The Sizewell C Project

5.6Ad Sizewell Link Road Flood Risk Assessment Addendum - Appendices B-D Part 1

Sizewell C Sizewell Link Road Flood Risk Assessment Addendum – Appendix B: Collated Comments from the Environment Agency received on 5th February 2020 and 4th August 2020

Plate 2.5: Long-section of the diverted channel (extract from drawing no. SZC-AD0310-WSP-SLRHDG-ZZ0000-DRW-HCD-300101)

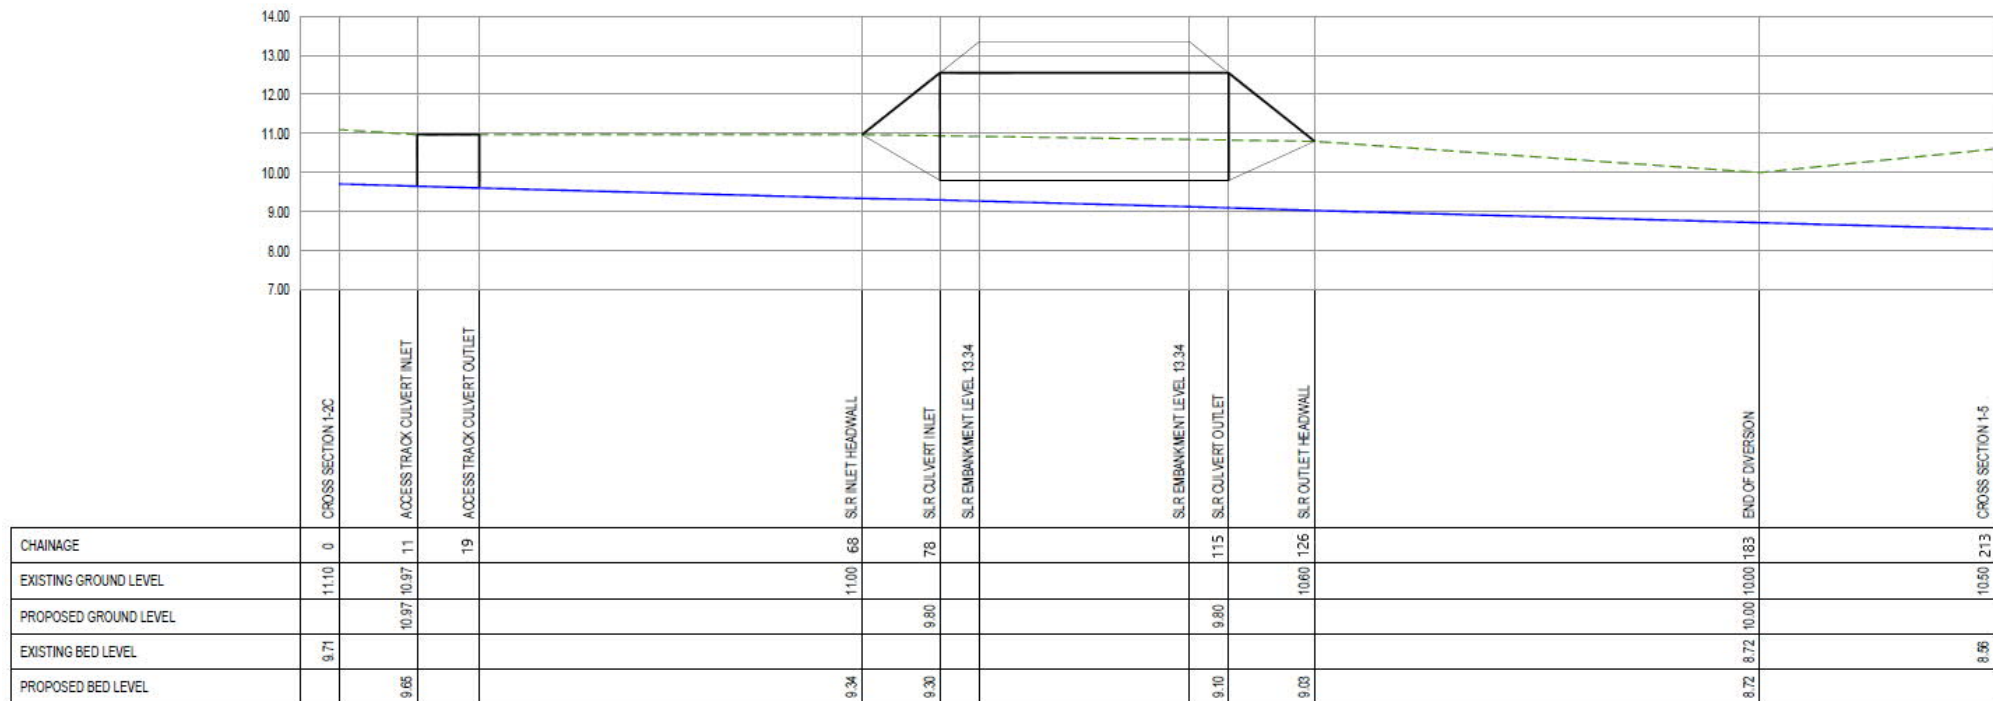
No.	Document Title	Paragraph number	Issue	Comment	Suggested solution	Priority	Date Raised	SZC Co.'s Response
6.1	Sizewell Link Road Fluvial Modelling Report	Plate 2.5	The proposed cross section of the new diversion channel at SW1 is substantially larger than the current watercourse.	The cross section of the existing watercourse is understood to be approximately 1.5m2 this drawing shows the top of the channel to be 9.4m wide which is much larger. The FRA also does not explain how the channel will be constructed. The new channel should be as natural as possible.	Please explain why the cross section shown has been chosen and why it does not replicate the existing channel. Provide cross sectional survey obtained to show existing channel dimensions to provide a comparison to the proposed design.	1	05/02/2020	Further details of the design of the re-aligned channel have been provided in the Modelling Report Addendum and the FRA Addendum.

Plate 2.6: Cross-section of portal culvert at crossing 2 (extract from drawing no. SZC-AD0310-WSP-SLRHDG-ZZ0000-DRW-HCD-300005)

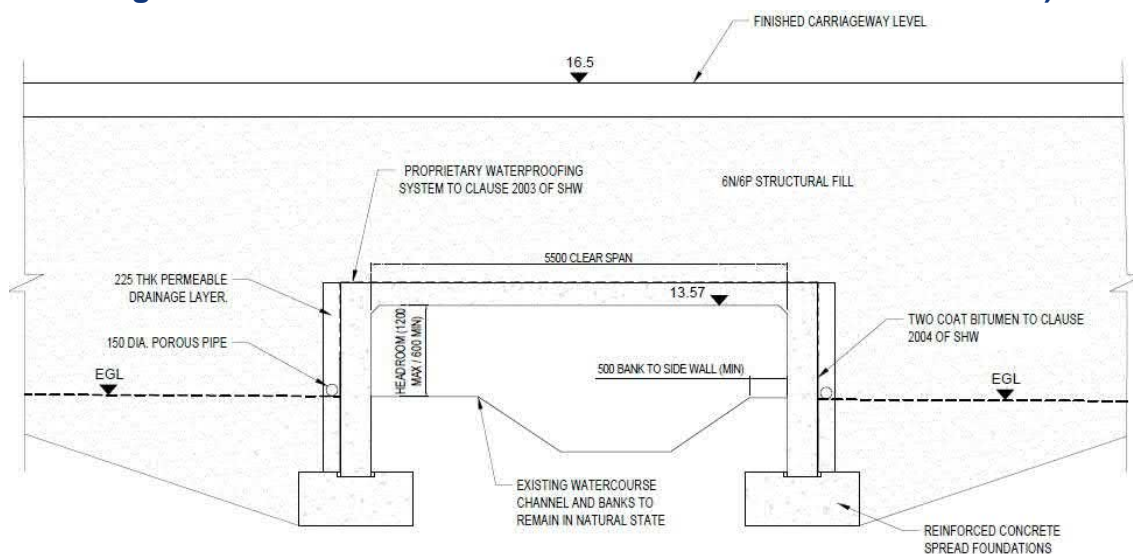
6.2	Sizewell Link Road Fluvial Modelling Report	Plate 2.6	SW1 crossing is now a T shaped concrete culvert. Material will be added to the bed and banks to naturalise the channel.	It is assumed that the cross sectional area shown in plate 2.6 and the model includes any material required to naturalise the culvert. This material could reduce capacity and impact on model results so must be included. It is not explained how or what sort of material will be used to create a natural bed and banks.	Confirm material will not reduce the capacity of the culvert and if it will this must be reflected in the modelling. Provide details on the material to be used to naturalise the bed and banks so we can determine it is suitable.	1	05/02/2020	Further details and clarification on the design and capacity of the culvert have been included in the Modelling Report Addendum.

Plate 2.7: Plan view of crossing 3 (extract from drawing no. SZC-AD0310-WSP-SLRHDG-ZZ0000-DRW-HCD-300006)

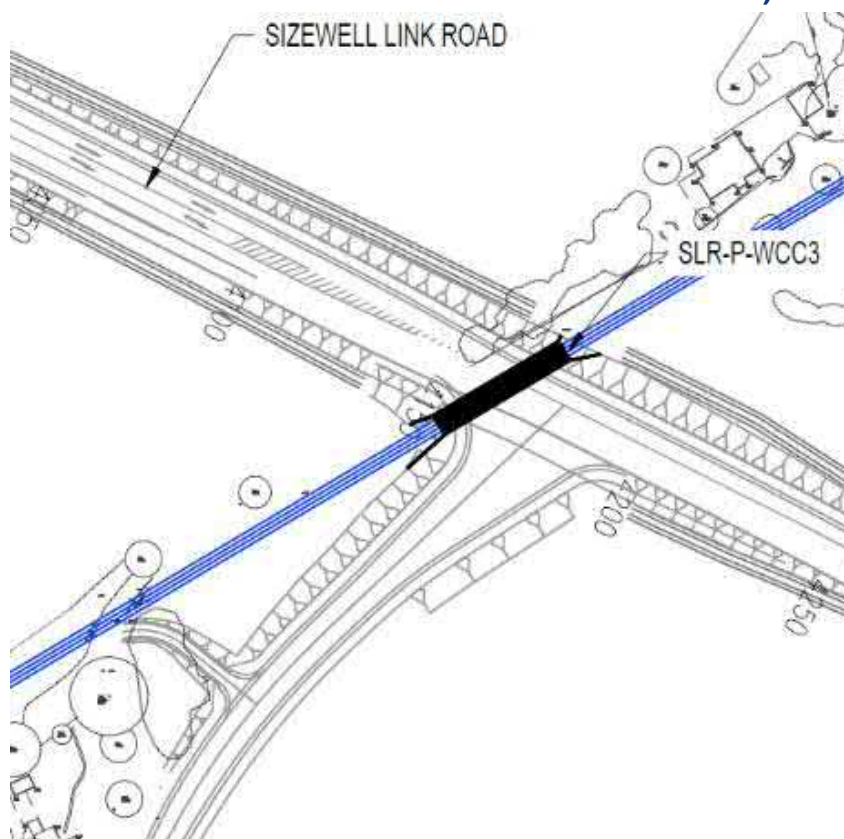
4.5	Sizewell Link Road Flood Risk Assessment	Plate 2.7	The proposed layout at SW3 is provided in plate 2.7, although this is not clear and appears unfinished.	It is not clear from the FRA or model report what the final design for the SW3 crossings are. It is understood an existing culvert will be extended with a portal culvert under Hawthorn Road and a flood relief culvert will also be installed. The description of the SW3 design in 2.2.21 does not appear to be consistent with the drawing in Plate 2.7	Provide clear plans and drawings for SW3 showing the existing and proposed arrangement. The information provided so far is not clear. Update the text to provide clarity and justify the final design in consultation with Suffolk County Council as it is an ordinary watercourse.	2	05/02/2020	Further design details (where available) have been discussed in the FRA Addendum.

5.9	Sizewell Link Road Fluvial Modelling Report	Plates 2.4 and 2.7	Plate 2.7 does not show where the flood relief culverts for crossing SW3 will be located. It is not clear how the locations of the proposed flood relief culverts relate to the modelled floodplain/outlines.	Plate 2.4 shows SW1 box culvert runs adjacent to portal culvert. A box culvert is shown on Plate 2.7 for SW3, but this is not clear. There is no mention of a portal culvert. Is this plan incomplete?	Provide updated final design arrangement plans and cross sectional drawings for SW1 to SW7.	2	05/02/2020	Further design details (where available) have been discussed in the Modelling Report Addendum.
6	Sizewell Link Road Fluvial Modelling Report	Plate 2.4	The surface water infiltration basin to the east of Fordley Road at SW1 is located on higher ground. As the surface water drainage design is not available it is difficult to understand how the road will drain to the infiltration ponds.	The field to the east of Fordley road where the infiltration basin is located is higher ground. Surface water is known to run off and drain to the low point at Fordley Road. The FRA should consider how to improve this in the first instance and must not increase flood risk as a result of the development.	Provide information on surface water drainage to Suffolk County Council. Evidence that flood risk will not be increased and where possible it has been reduced overall in line with paragraph 5.7.3 of National Policy Statement EN1 and paragraph 160 of the National Planning Policy Framework.	2	05/02/2020	Further details on surface water drainage design (where available) and flood risk have been provided in the FRA Addendum.

Plate 2.10: Cross-section of the flood relief culvert at crossing 7 (extract from drawing no. SZC-AD0310-WSP-SLRHDG-ZZ0000-DRW-HCD-300004)

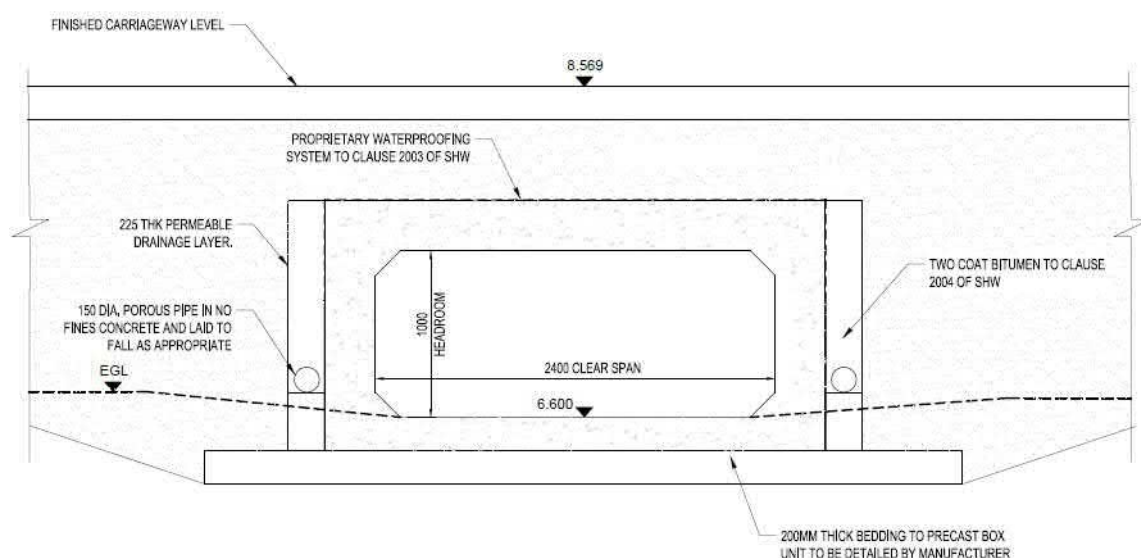
1.3	SZC_Bk5_5.6_AppxA_Sizewell_Link_Road_Modelling_Report.pdf	Plate 2.10/Hydraulic model	Discordance between what is shown in Plate 2.10 and what is represented in the hydraulic model at crossing SW3	Proposed revised layout at crossing SW3 long sections do not align with the dimensions shown in the model. Particularly the bank levels. For example Plate 2.1 suggests a bank level through the culvert of 9.4mAOD but inspection of section SW3_C2us reveals this (9.4m) looks more like portal culvert soffit level. Similarly for the Hawthorn Rd Crossing culvert the bank levels shown in Plate 2.10 don't seem to tie in with those shown in cross section SW3_C1us.	Correct the model or plate in the report depending on which is incorrect	1	14/09/2020	The model has been revised with additional survey data and the latest / improved (where required) design information. Updated results and further details on the modelling are provided in the Modelling Report Addendum.
